Access Compliance Report

Public Rights-of-Way

Intersection ID: 48634	Main Street: GRANDE_HEIGHTS_DR	Cross Street: DOMINION_CREST_DR	Location: SE
ADA ID: A30210F002A7	Ramp Type: Perp	Initial Pass/Fail: Fail	Overall Compliance: No
Severity Score: 12.5			
Codes/Mitigation Info/Possible Solution		Field Measurements/Component Compliance

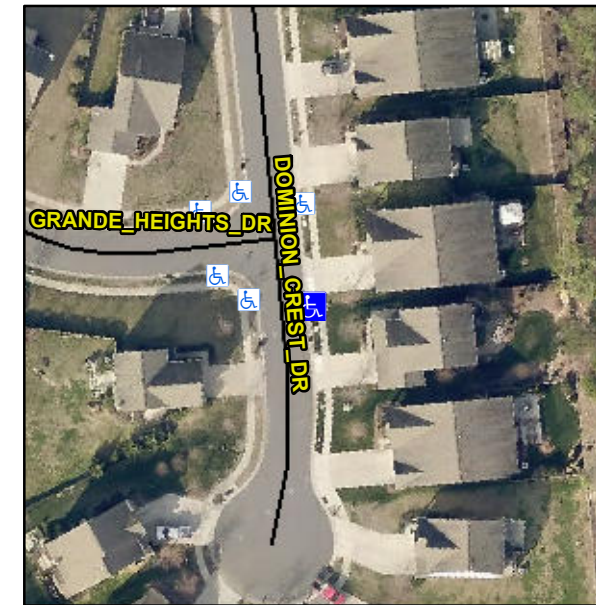
Not Found, R304.2.2

Compliance	Description	Data	Compliance	Description	Data
N/A	Ramp Length (in)	47.0	No	Ramp Slope (%)	8.9
Yes	Ramp Width (in)	48.0	Yes	Ramp XSlope (%)	1.4
N/A	Flare Type LT	N/A	N/A	Flare Type RT	N/A
N/A	Flare Slope LT (%)	N/A	N/A	Flare Slope RT (%)	N/A
N/A	Flare Traversable LT?	N/A	N/A	Flare Traversable RT?	N/A
N/A	Landing Length (in)	N/A	N/A	DWS Provided?	N/A
N/A	Landing Width (in)	N/A	N/A	DWS Contrast?	N/A
N/A	Landing Slope (%)	N/A	N/A	DWS Length (in)	N/A
N/A	Landing X Slope (%)	N/A	N/A	DWS Full Width?	N/A
N/A	Landing Curb? (Y/N)	N/A	N/A	DWS Offset (in)	N/A
N/A	Shared Landing?	N/A			
N/A	Gutter Ponding?	N/A	N/A	Gutter Slope (%)	N/A
N/A	Gutter Lip Ht (in)	N/A	N/A	Gutter X Slope (%)	N/A
N/A	Painted X Walk1?	No	N/A	Painted X Walk2?	N/A
	X Walk 1 Direction	To W		X Walk 2 Direction	N/A
N/A	X Walk 1 Width (in)	N/A	N/A	X Walk 2 Width (in)	N/A
	X Walk 1 Slope (%)	4.1		X Walk 2 Slope (%)	N/A
	X Walk 1 X Slope (%)	2.3		X Walk 2 X Slope (%)	N/A

Remove & Replace Entire Ramp.
